Tintenbar to Ewingsdale

Upgrading the Pacific Highway

Environmental Assessment
Submissions Report and
Preferred Project Report

May 2009

Figure 4.1h Preferred project

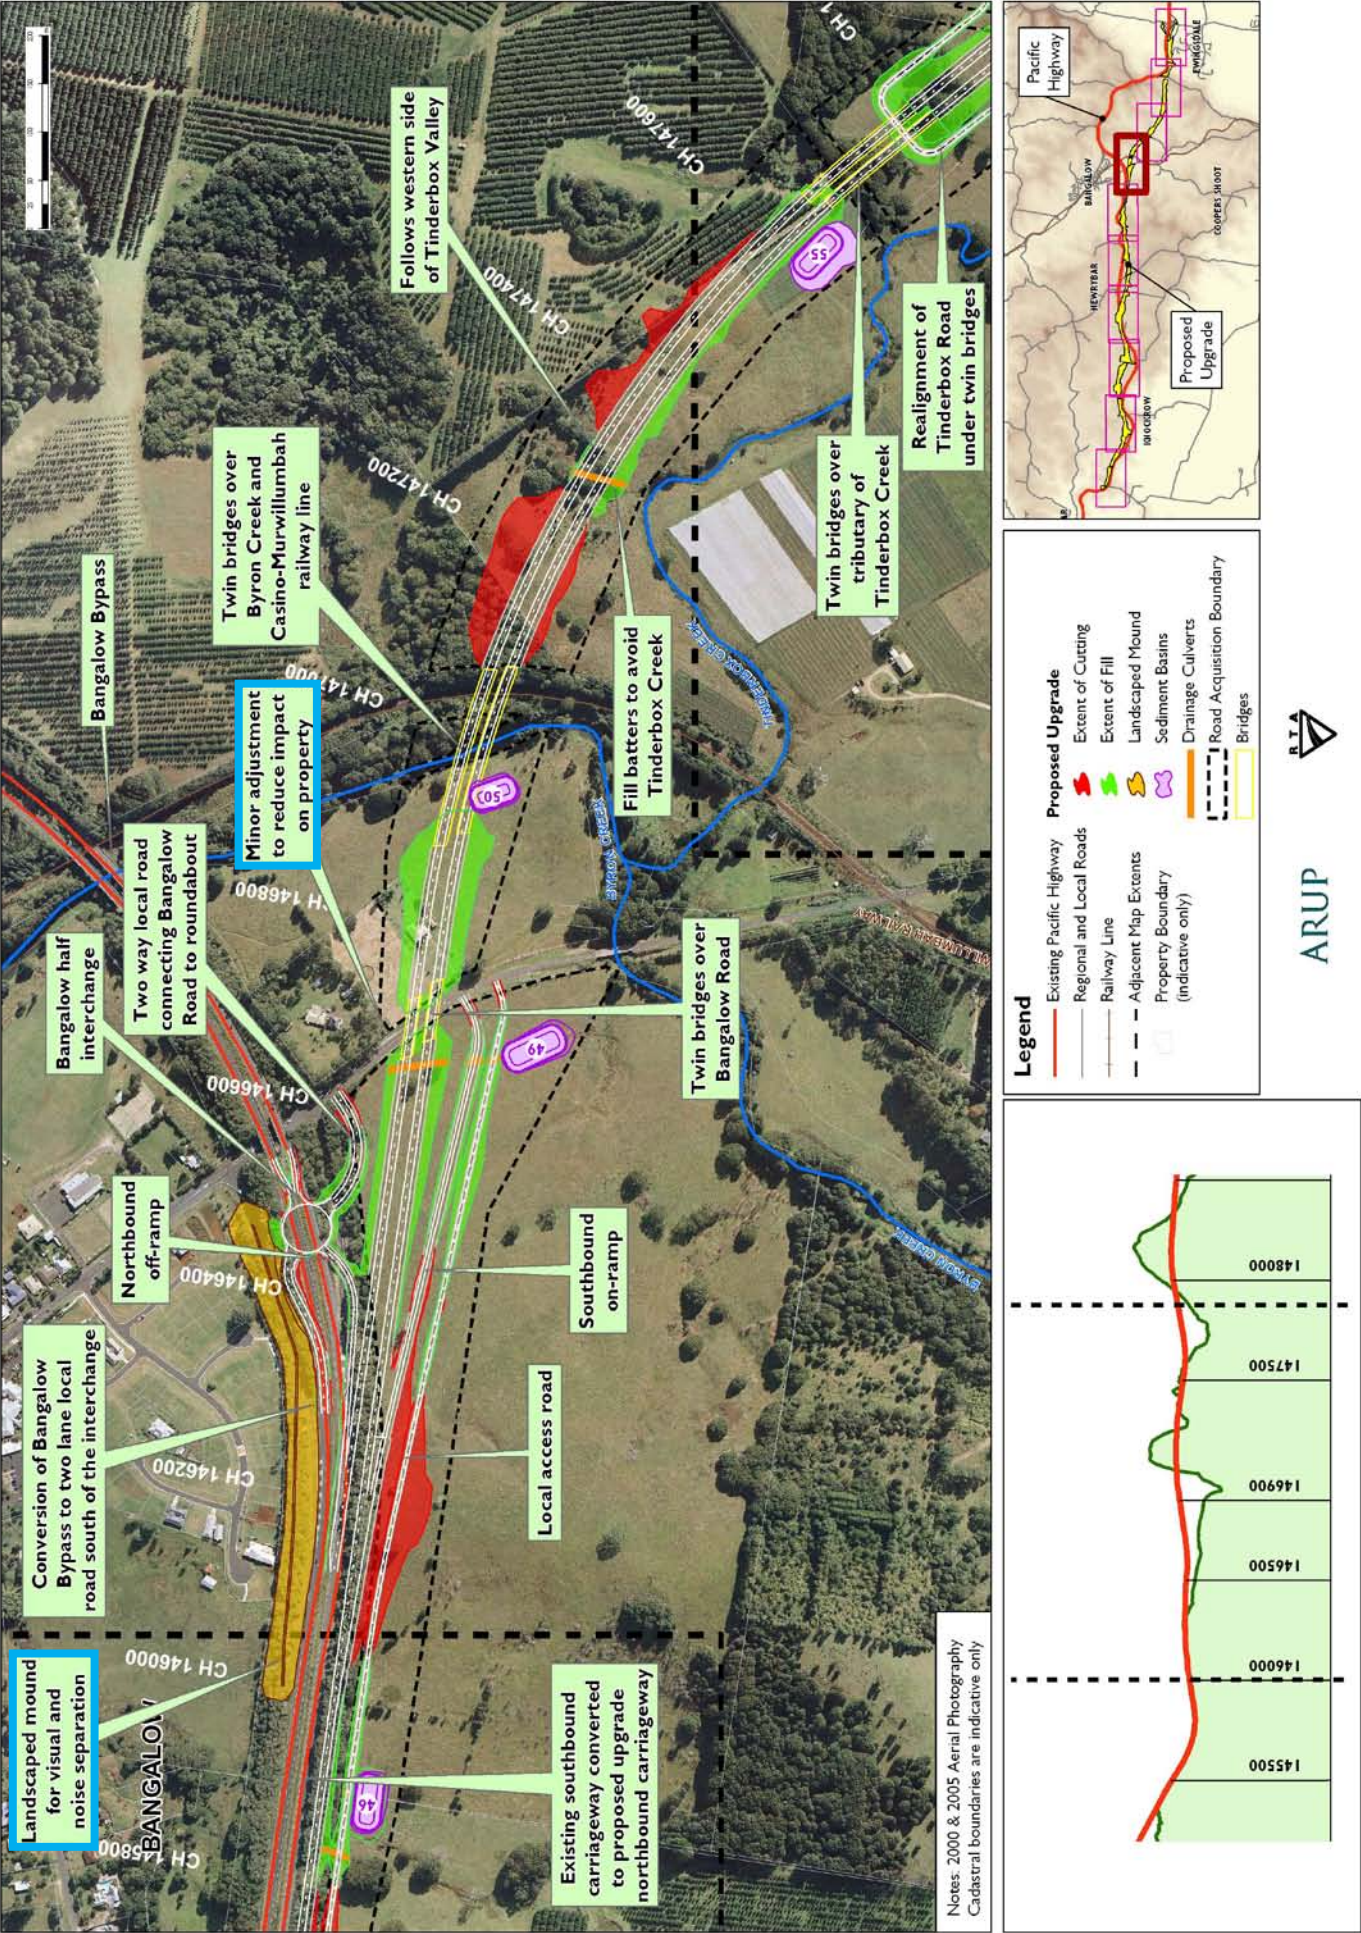
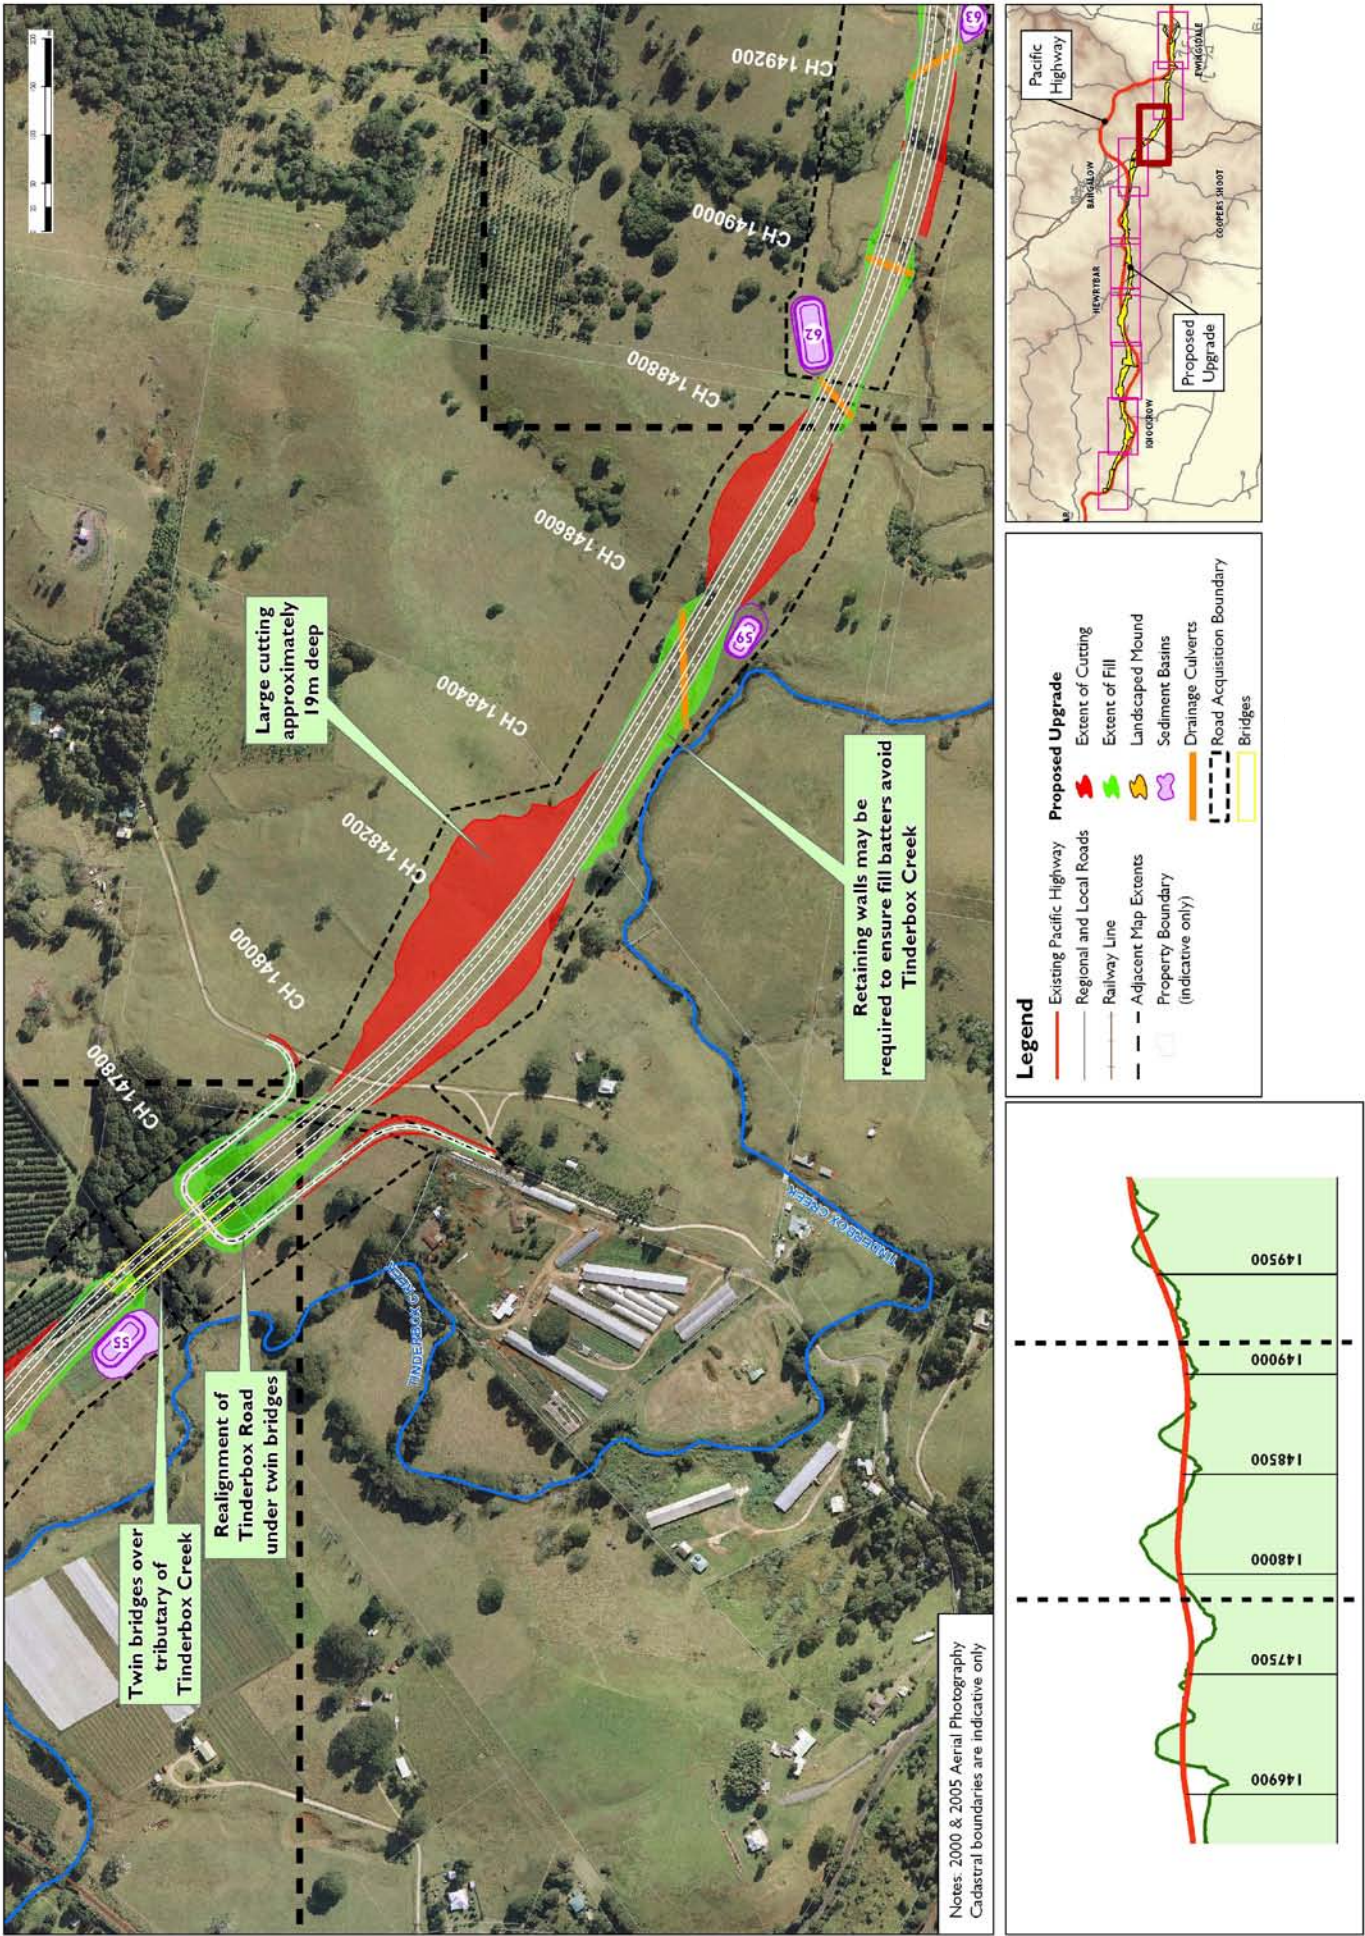
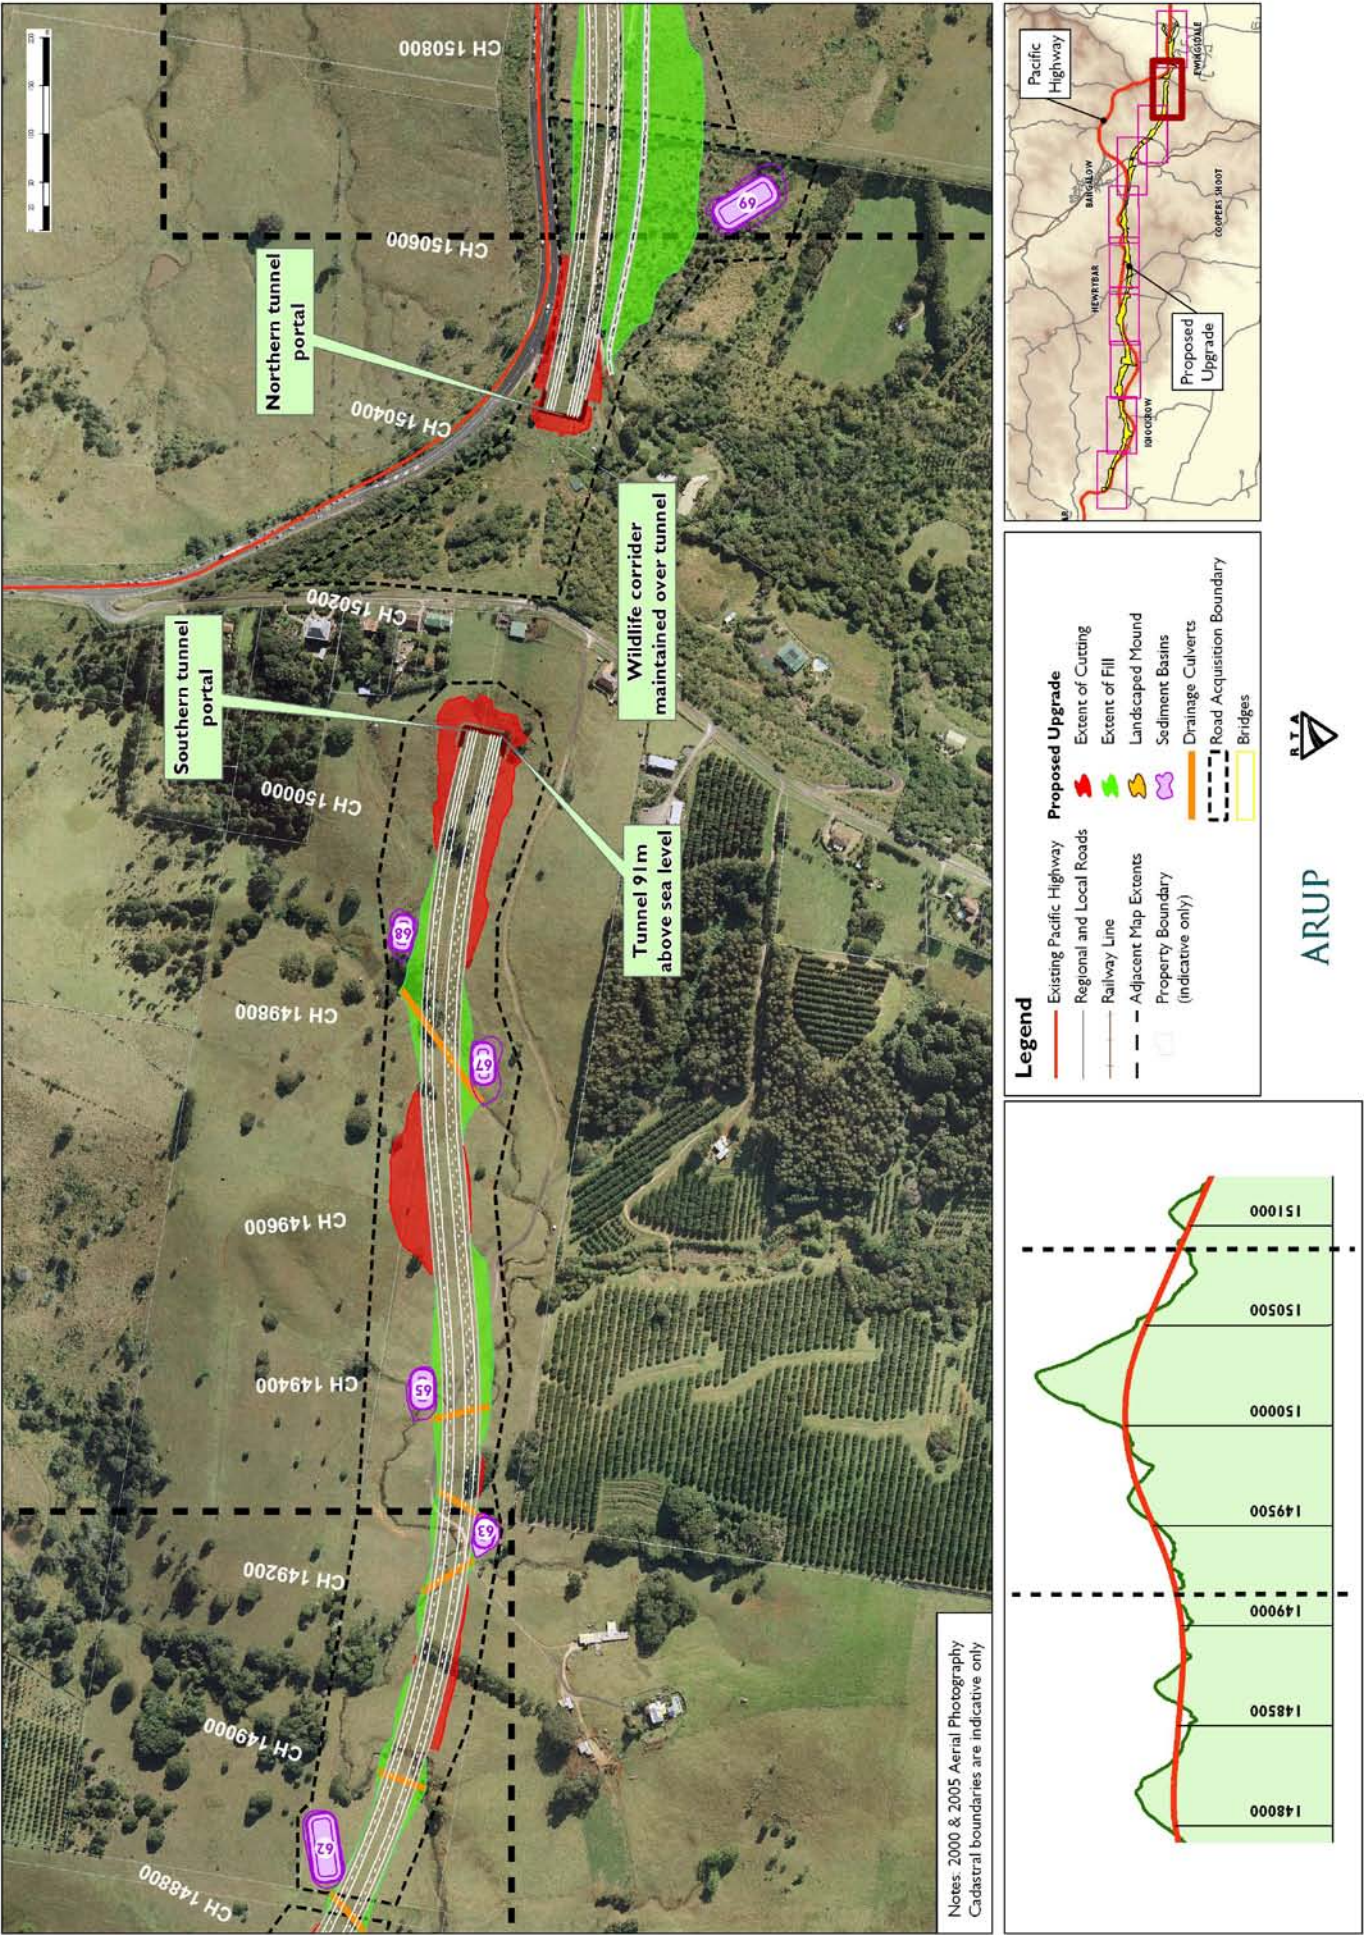
- > Concern over increased traffic on local roads
- > Concern over potential increased noise impacts.
- > Concern over visual and light spill impacts.
- > Questioning of the justification of the interchange in light of the projected level of use.

After further detailed consideration, the RTA has determined that the Ivy Lane interchange be removed from the proposed upgrade. The removal of the interchange is discussed in detail in Section 4.1 as part of the preferred project report.

As well as the interchange itself, the underpass at Ivy Lane would also be removed from the proposal and the local access road arrangements on the western side of the upgrade would be amended to provide access to the properties on that side. The altered configuration is shown in figure 4.1c.
